PLANNING ALTERATIONS
LEVEL 02

Stage 1a - Level 2

Stage 1a - Long Elevations

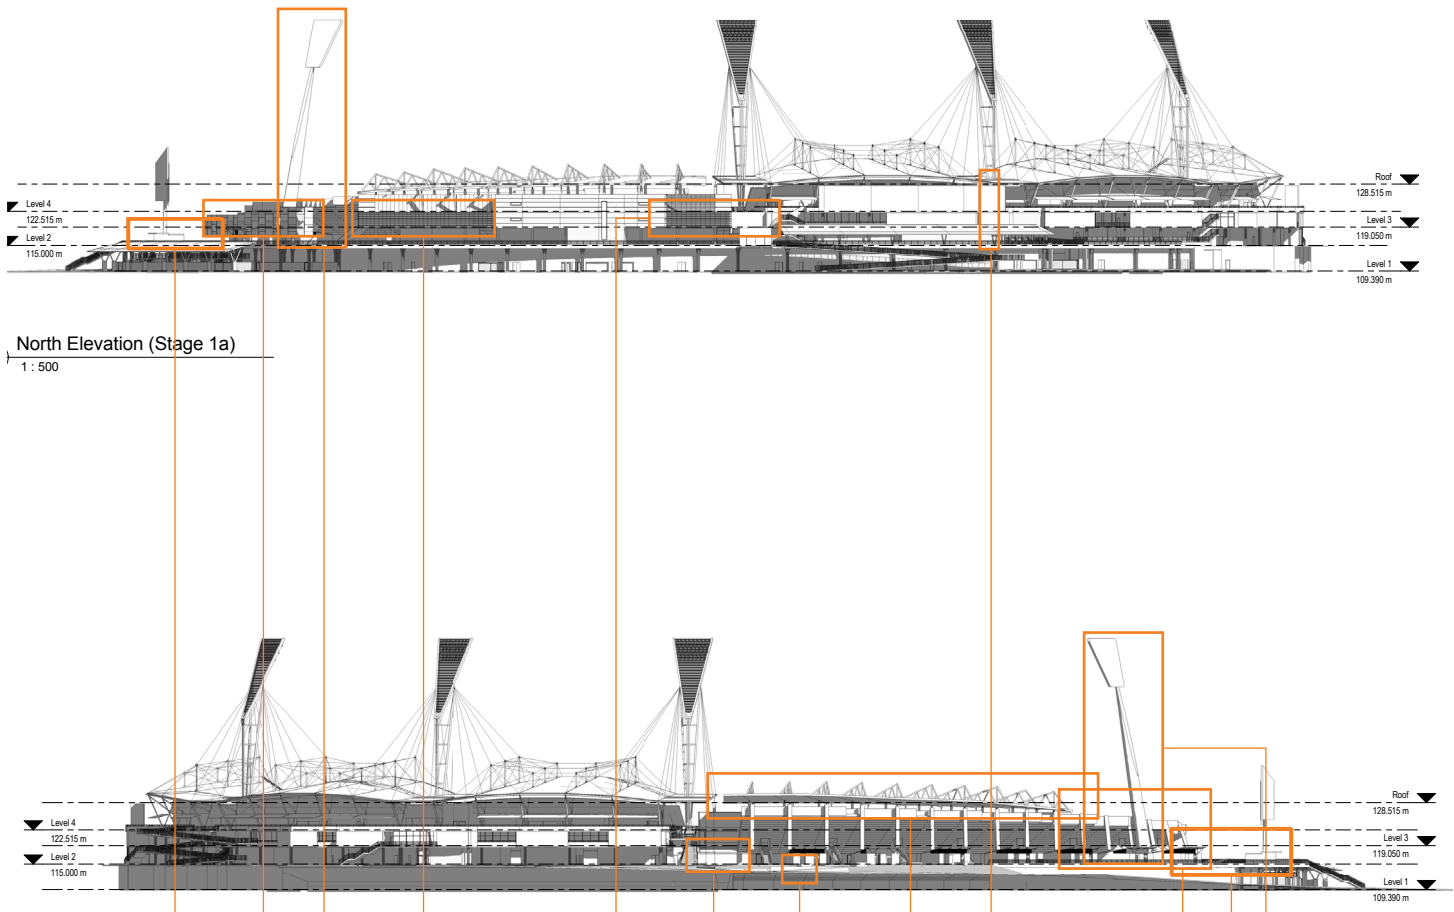
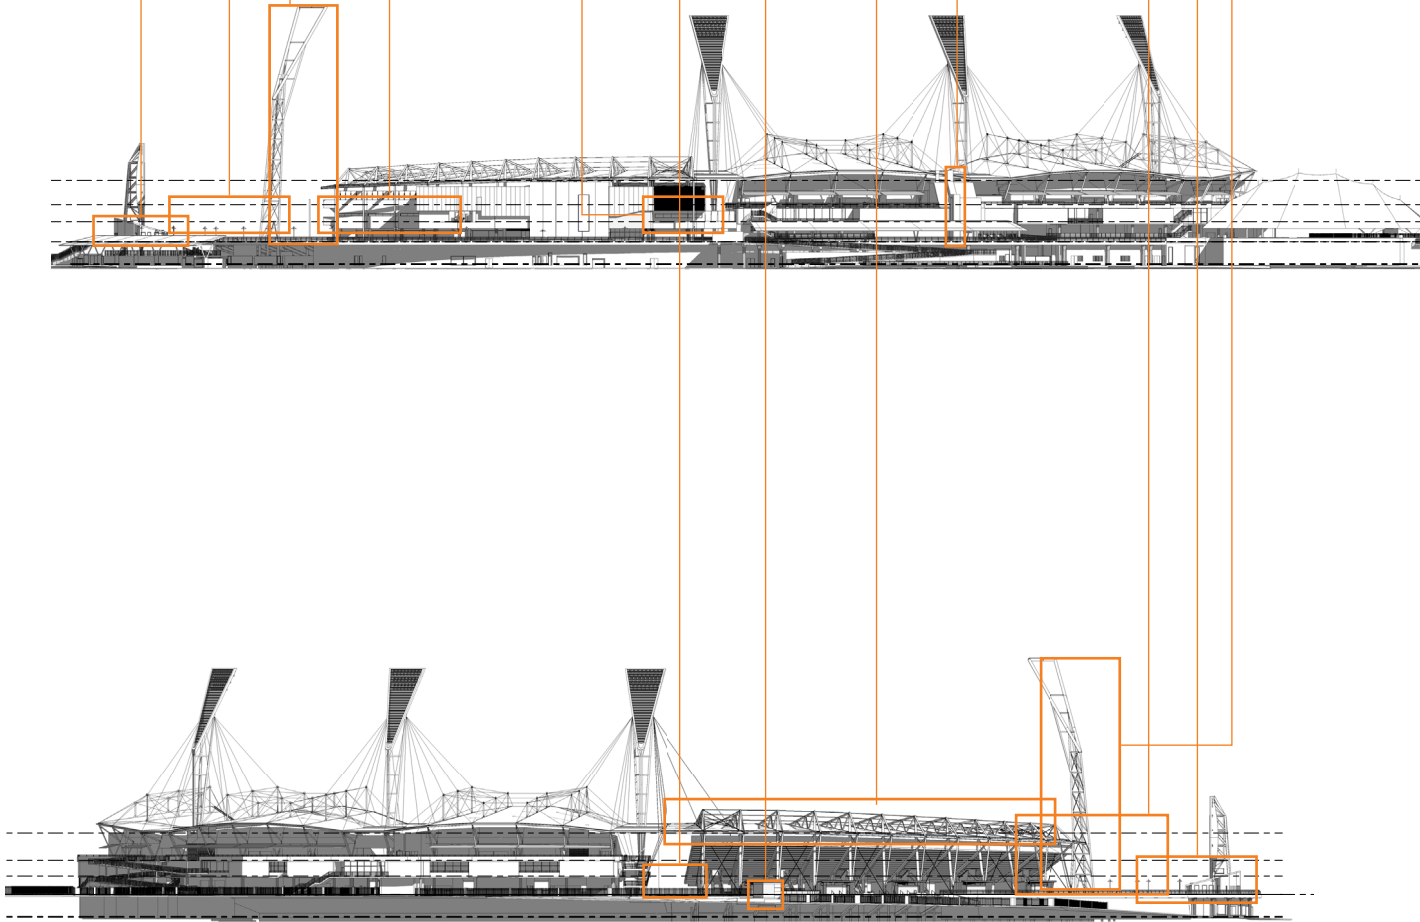
1. Removal of northern seating hill
2. Removal of NW upper tier GA seating
3. Redesign and relocation of light towers to better match existing light towers and improve efficiency
4. Removal of green wall from NW section of corporate stand and redesign of corresponding facade
5. As above
6. Removal of SE F&B
7. Addition of entry turnstile building
8. Addition of roof over permanent SE upper tier GA seating
9. Addition of exhaust duct from Level 1 kitchen
10. Removal of two bays from SE upper tier GA seating

Stage 1a - Short Elevation

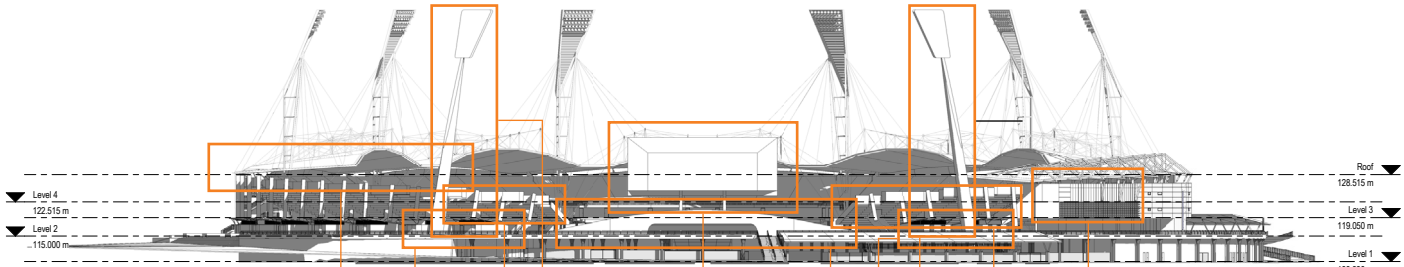
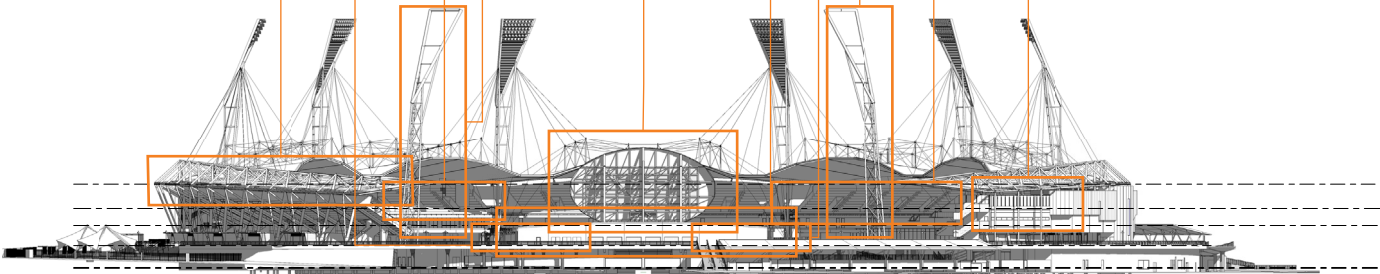
- 1. Addition of roof over SE upper GA stand
- 2. Relocation of two northern amenity blocks adjacent to F&B under video board
- 3. Removal of two bays from SE upper tier grandstand
- 4. Redesign and relocation of light towers to better match existing light towers and improve efficiency
- 5. Redesign of video board from rectangle to oval 'Sherrin' form
- 6. Removal of northern seating hill
- 7. Relocation of two amenity blocks adjacent to F&B under video board
- 8. Removal of NW upper tier GA grandstand
- 9. Removal of green wall from NW section of corporate stand and redesign of corresponding facade
